Subject: Communication Under the Open Door Policy - SECY 15-0123, STP COLA Hearing Scheduled on November 19, 2015
Attachments: OpenDoorPolicy-Commissioners-11022015.pdf

Technical Concerns Regarding the Uncontested Hearing for Issuance of Combined Licenses for the South Texas Project Units 3 and 4, SECY 15-0123

Prepared by **Hosung Ahn**, Hydrologist, NRO/DSEA/RHMB, November 2, 2015

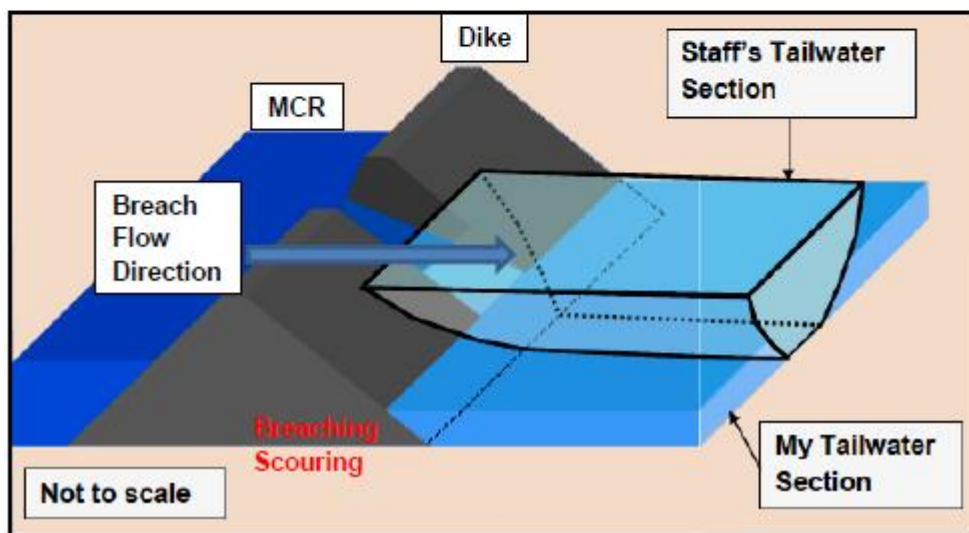
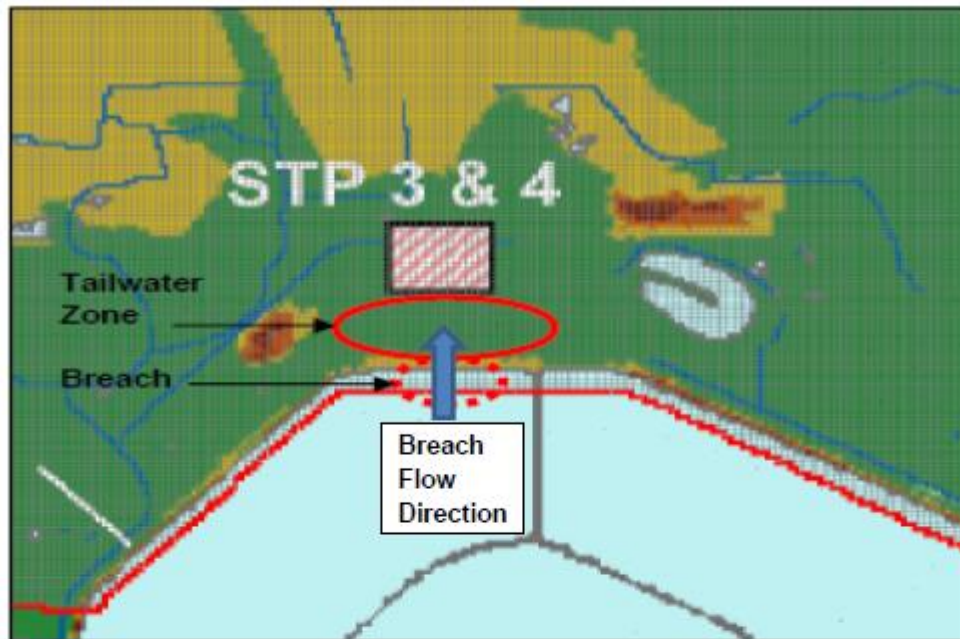
My re-analysis revealed that both licensee's and staff's above conclusions are inaccurate. Their sensitivity analyses were based on a fictitiously-drawn small tailwater cross section above the land surface (see Figure 1 (bottom)). This results in artificial constriction of the breach process in the model. That is, the fictitious tailwater channel induces a small breach head (i.e., the water level difference between MCR and tailwater section) by inadvertently increasing tailwater level during the early stage of a piping failure.

The actual breach tailwater zone is a wide and flat open area (over 0.8 miles as shown in Figure 1 (top)). However, the tailwater cross sections specified in the licensee's and staff's BREACH models were small enough (bottom width of 600 ft) to constrict a full breach growth. This is a rudimentary modeling error. All three external peer reviewers failed to recognize this issue and/or misinterpreted the BREACH modeling and result presented in the re-analysis report.

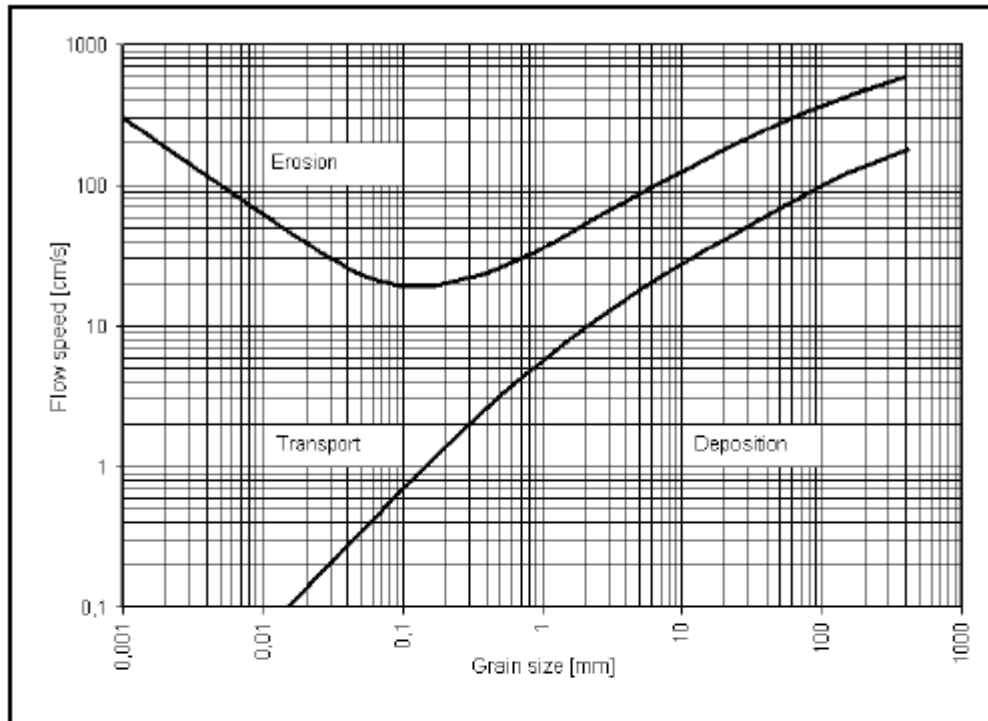
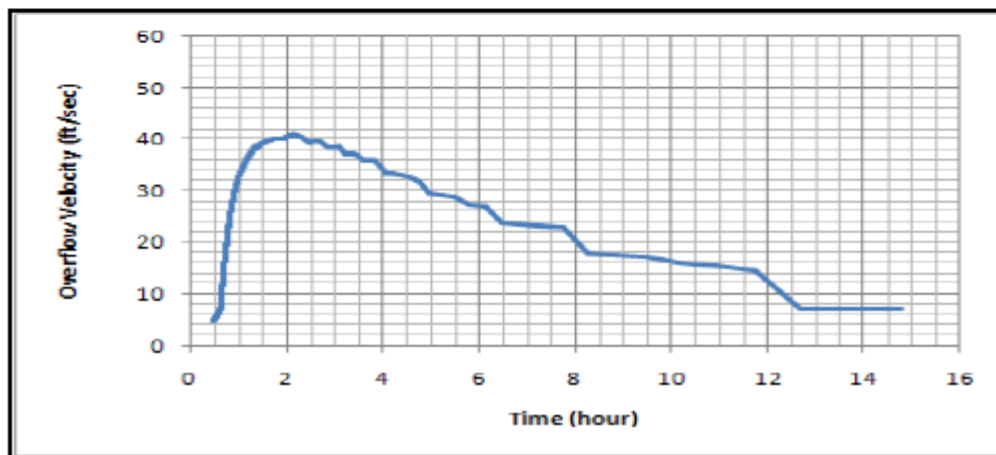
The result of the MCR BREACH runs indicates that the breach flow velocities range from 10 feet per second (ft/s) to 40 ft/s (Figure 2 (bottom)). These velocities exceed significantly the critical erosion velocity of 10 ft/s (from the Hjulstrom Curve in Figure 2 (top)) for the given clay soils with a particle size of 0.001 millimeters as specified in the BREACH. The erosion process represented by the Hjulstrom curve developed in 1935 is old but intuitively simple. The theory of the hydrologic erosion process has been advanced substantially during the past 40 years as many accurate erosion equations are now available. The new erosion equation predict the erosion capacity based not only on soil particle size and flow velocity, but also on additional soil parameters such as cohesion coefficient, friction angle, bottom roughness, particle distribution, and critical shear stress coefficients. The Smart Equation adopted in the BREACH model is one of them as it uses both breach flow and soil characteristics.
